Subject: Response to August 31, 2018 EPA/NJDEP Letter Regarding Former Chevron

Perth Amboy Facility Water Body Sediment Sampling

Facility EPA ID#: NJD081982902

FORMER CHEVRON PERTH AMBOY FACILITY SUPPLEMENTAL FIELD SAMPLING AND ANALYSIS PLAN SEDIMENTS

Figure 5-1 2003 Arthur Kill Dredging Areas October 10, 1997 Water Front Development Water Quality Certificate Permit December 23, 2001 Upland Placement Survey

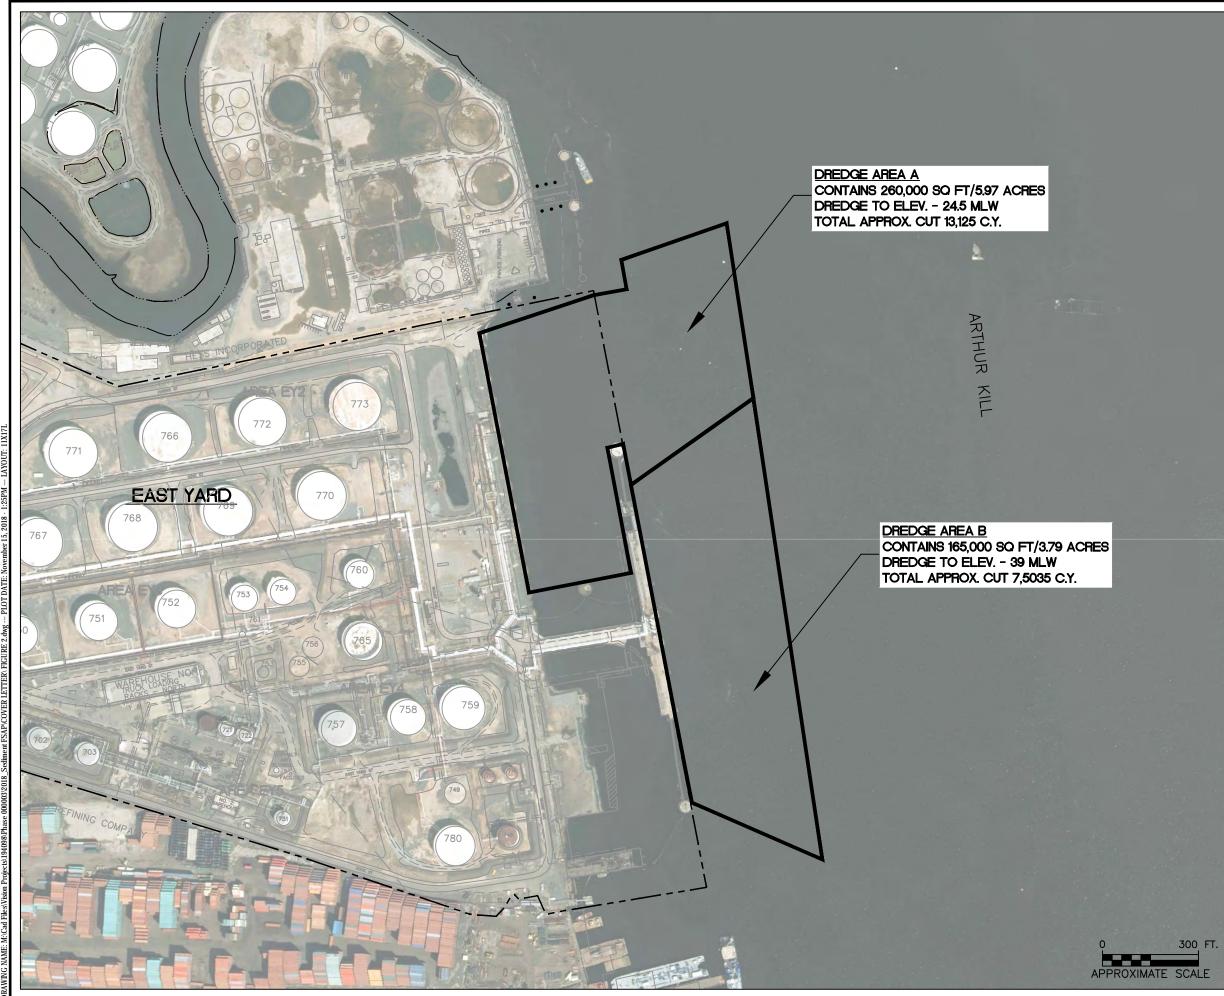
Arthur Kill Comment 3 - EPA is requesting additional information on the dates/location of dredging in the Arthur Kill.

Chevron Response to Arthur Kill Comment 3 - As discussed at the September 17, 2018 meeting, Chevron's Arthur Kill dock area (Area A [Berths 2, 3 and 4] and Area B (Tanker Berth]) has been subject to prior maintenance dredging by Chevron. Dredging information for this area is provided in Attachment 5, including the 1997 NJDEP Land Use Permit for maintenance dredging and an aerial photograph base map with an outline of the dredged area that includes the location, depths and volumes associated with the dredging activities (Figure A-1). The dredging was completed during November 2003. The dredging material was approved for upland placement by the NJDEP as clean fill and was used as backfill in the former East Yard Basin.

FIGURE 2.dwg

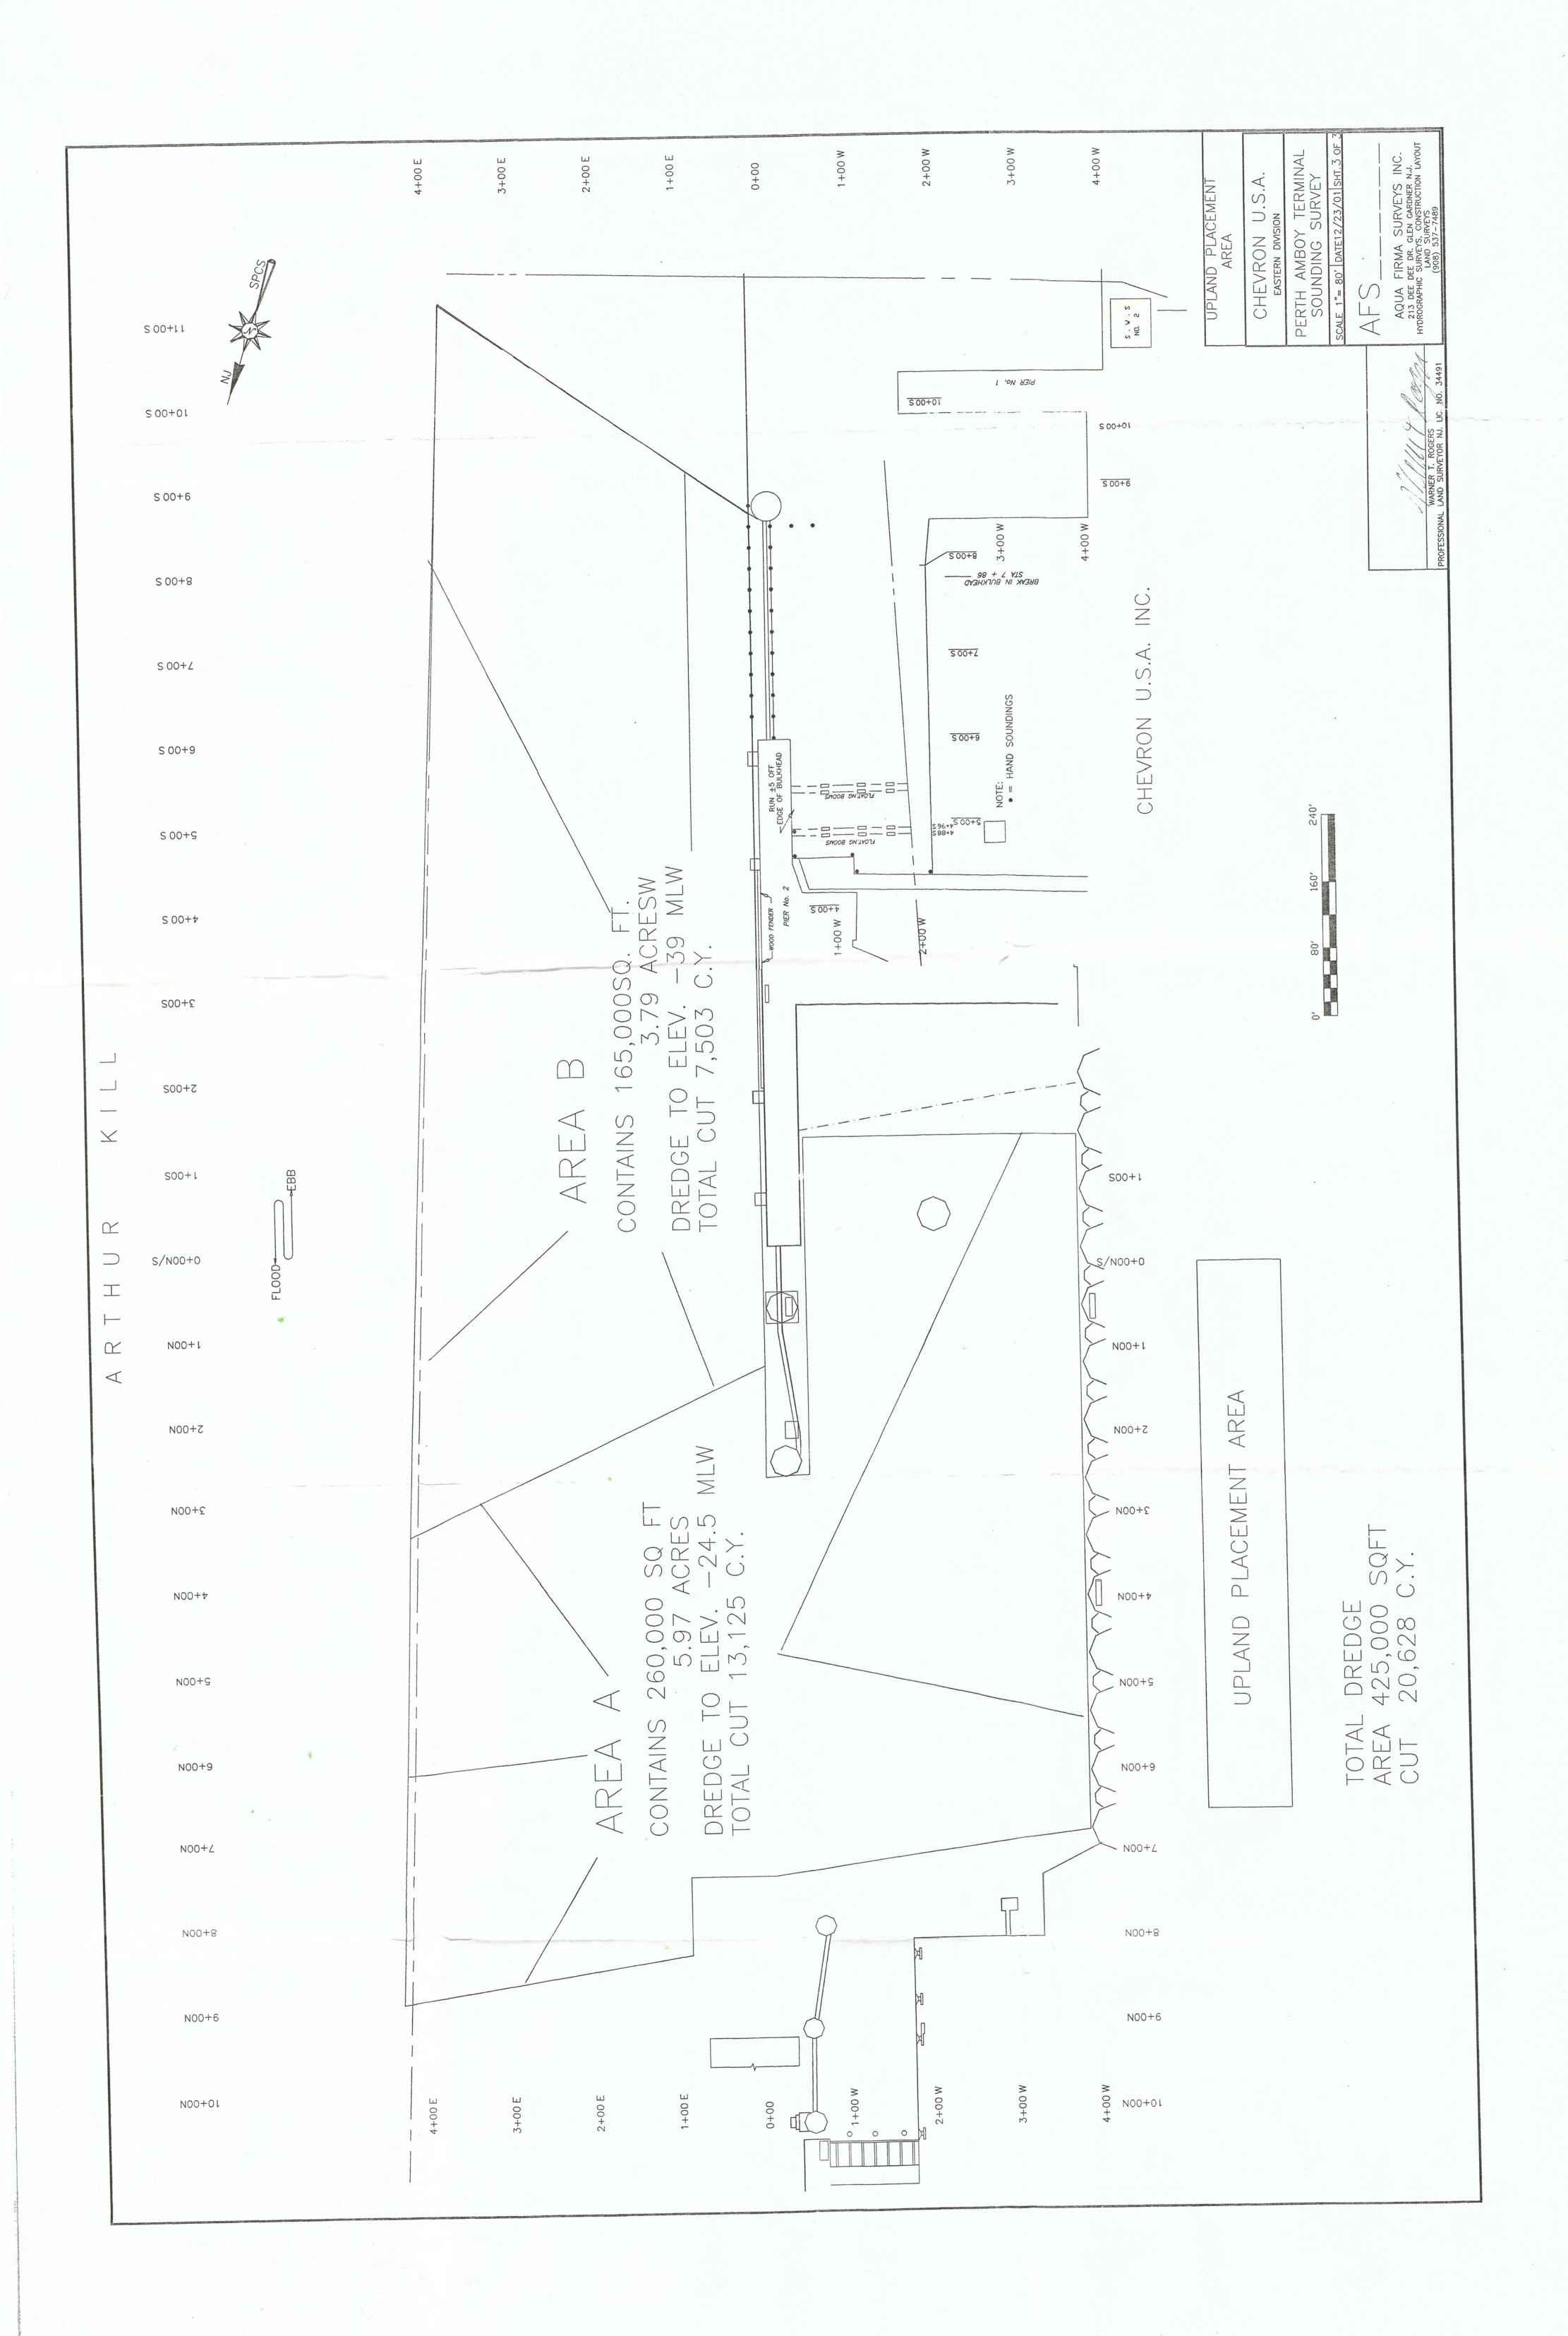
Woodbridge Creek Comment 2 - EPA is requiring an additional transect to sample for all contaminants (VOCs, SVOCs, EPH, PCB, Metals, Organochlorine Pesticides, TOC, and particle grain size) at the midpoint between SEO -09 and SED-06. The transect should contain 3 points (A-C), with C being closest to the facility, B the midpoint, and A located on the opposite side of the facility. If results show hotspots, Chevron must delineate by adding additional transects 200 feet from the hotspot in the upstream and downstream direction.

Chevron Response to Woodbridge Creek Comment 2 - As shown on Figure 2 in Attachment 1 (SFSAP), Chevron will add two additional transects in between SED-06 and SED-09. Samples will be collected from the surface interval and from the subsurface interval exhibiting the greatest potential for contamination, determined by photoionization detector or visual observation. As discussed in the September 17, 2018, samples will be analyzed for extractable petroleum hydrocarbons (EPH), volatile organic compounds (VOCs), semi-volatile organic compounds (SVOCs), priority pollutant Metals (PP Metals), total organic compounds (TOC) and particle grain size\ (but excluding Pesticides). As agreed upon during the September 17, 2018 meeting, Chevron does not need to further delineate hot spots to comply with the requirements of 2013 HSWA Permit.

Data Gaps Woodbridge Creek New Boring Locations: Chevron will add two additional transects (three borings per transect) in between SED-06 and SED-09. These additional transects are SED-23-A,B,C and SED-24-A,B,C as shown on Figure 2 and Table 1. Samples will be collected from the surface interval and from the subsurface interval exhibiting the greatest potential for contamination, determined by field observations.
